ARC REVIEW CODE: R2105101

Name of Proposal: Blackhall Studios Atlanta II DRI #3214

Review Type: Development of Regional Impact **Date Opened:** May 10, 2021 **Date Closed:** May 26, 2021

Description: A Development of Regional Impact (DRI) review of a proposal to build an additional phase of the Blackhall film/TV production studios and related uses. The 165-acre site is located in unincorporated DeKalb County south of Constitution Road SE between Moreland Avenue (SR 42/US 23) and Bouldercrest Road SE. The site is bounded by the South River to the north and I-285 to the south. Access would be provided with a new connection to International Park Drive SE and a connection through the first Blackhall phase on Constitution Road. The project proposes approximately 538,500 SF of studio space, 420,000 SF of warehouse space, 200,100 SF of offices, and 22,000 SF of on-site catering space. The local trigger action is a rezoning. Expected buildout is 2024.

OVERALL
SITE PLAN

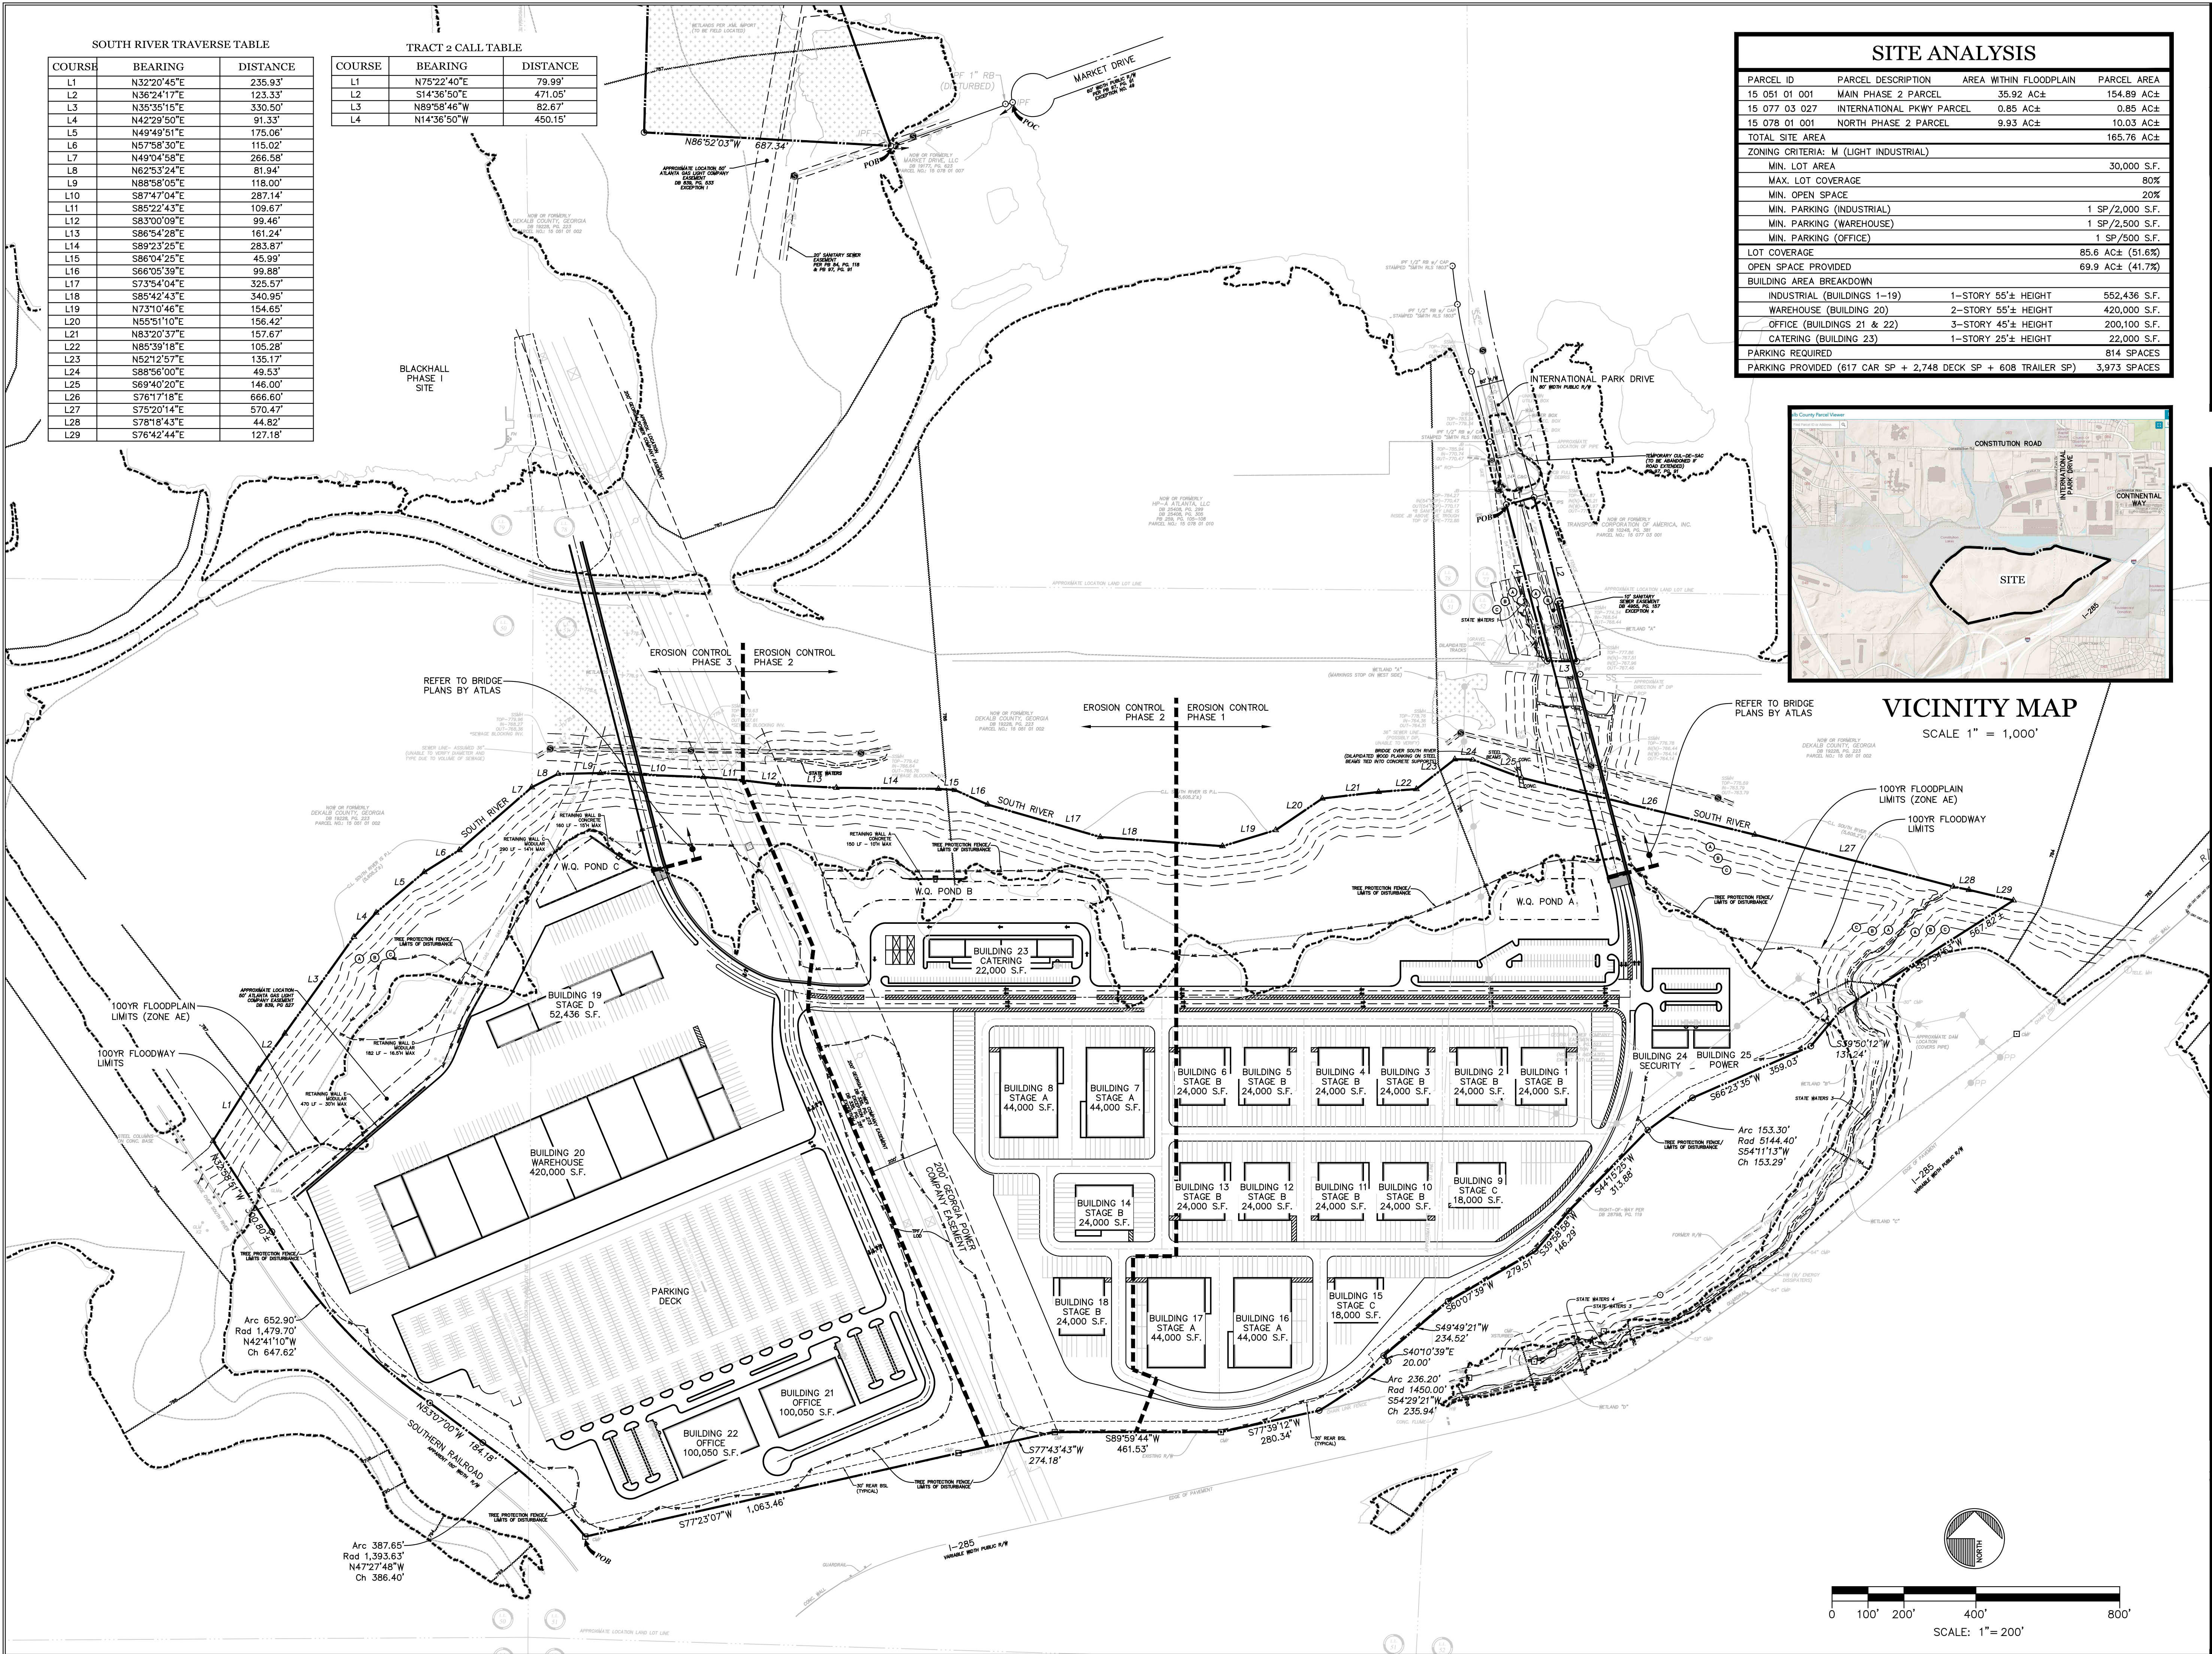
The proposed DRI represents a major development and addition of impervious surface along the South River corridor within the boundary of this planning effort. The submitted site plan estimates 84.1 acres of total paved/developed acreage and 81.7 acres of total landscaped surface. The developer, local government, and advocacy groups should begin work immediately to identify any potential conflicts from the DRI with future public greenspace opportunities and environmental consequences.

The project can further support The Atlanta Region's Plan in general by incorporating other aspects of regional policy, including green infrastructure and/or low-impact design best practices throughout the site in general, in parking areas, on site driveways, in stormwater detention facilities, and as part of any improvements to site frontages. Please see additional comments from ARC's Natural Resources Group. They note that the county and state buffers along the river and stream on the submitted site plan should be more clearly defined.

The South River forms the northern boundary of the project property. In addition, both the submitted site plan and the USGS coverage for the project area show one stream at the western edge of the property flowing into the South River. Buffers are shown along the river and on both sides of the tributary stream. Although identified only by letters, with no legend on the submitted plans, the buffers appear to be the County buffer and State Erosion and Sediment buffer. The only intrusions shown are two bridge crossings across the South River an area of disturbance shown at the outer edge of the buffer along the South River. These intrusions are subject to the requirements of the County and State buffers and may require variances. Any unmapped streams on the property may be subject to the DeKalb Buffer ordinance. Any unmapped streams and waters of the state on the property are also subject to the State 25-foot Erosion and Sediment Control Buffer.
